From: Franzone, Steve <Steve.Franzone@fpl.com>
Sent: Friday, June 10, 2016 1:22 PM
To: Comar, Manny
Cc: TurkeyCOL Resource; Maher, William; Burski, Raymond
Subject: [External_Sender] Chap. 8 vs Bulletin 2012-01
Attachments: 2012-01_PagesfromPART_10.pdf; Supplemental Response to NRC RAI Letter No 65.pdf; Pages from FSAR_CHAP08.pdf

Turkey Point Units 6 & 7
COL Application
Part 10 — License Conditions and ITAAC

Re: Florida Power & Light Company
Proposed Turkey Point Units 6 and 7
Docket Nos. 52-040 and 52-041
Supplemental Response to NRC Request for
Additional Information Letter No. 065 (eRAI 6750)
Standard Review Plan Section 08.03 – Stability of Offsite Power Systems

Supplemental Response to NRC RAI No. 08-1 (eRAI 6750)

Figure 1: Main AC Power Station Simplified One-Line Diagram

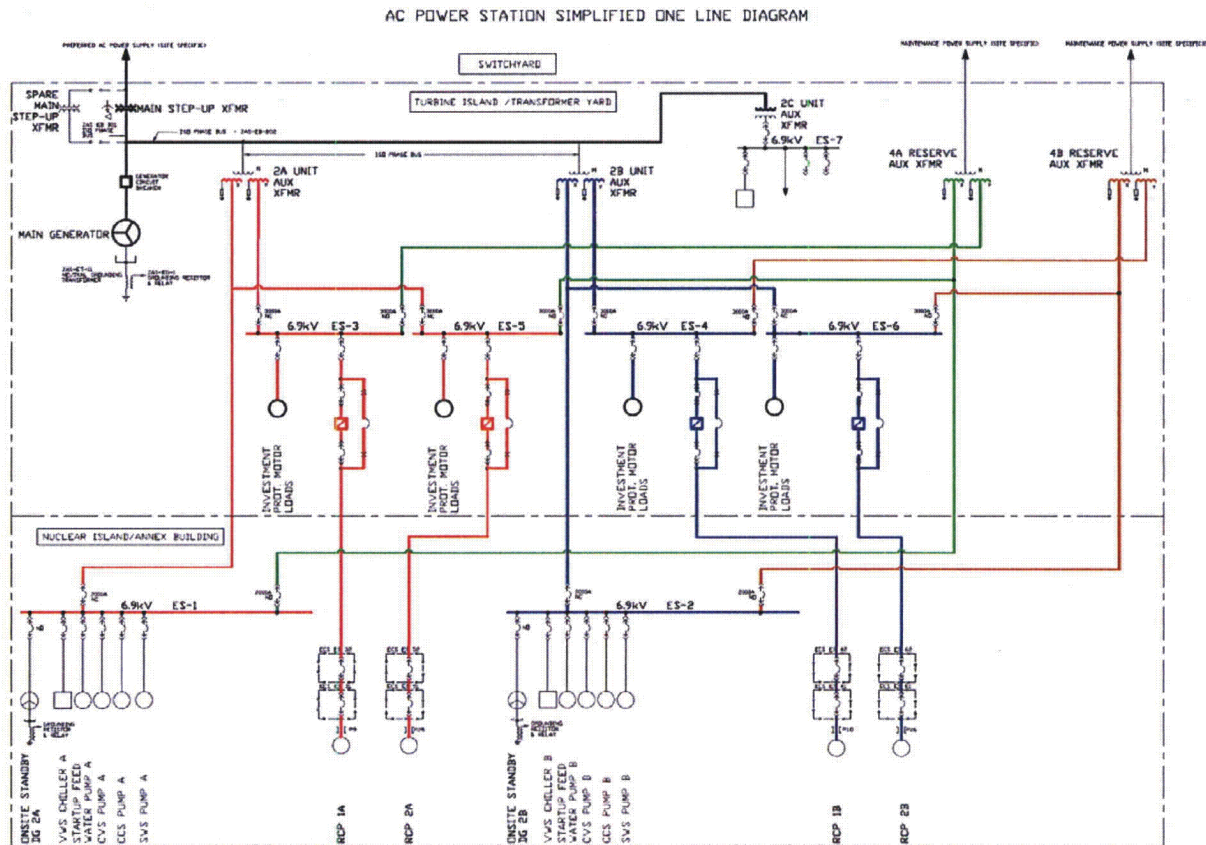
Identify which offsite circuit is credited to meet the GDC 17 requirements, considering the partial exemption for AP1000 plants.

The credited GDC 17 offsite power supply for the AP1000 plant is the Preferred AC Power Supply shown in Figure 1. The Preferred AC Power Supply is backfed through the three single phase MSUs, labeled "MAIN STEP-UP XFMR" as shown on Figure 1. The Preferred AC Power Supply is connected to the main generator bus and through the unit auxiliary transformers (UATs) 2A and 2B to the plant electrical distribution system.
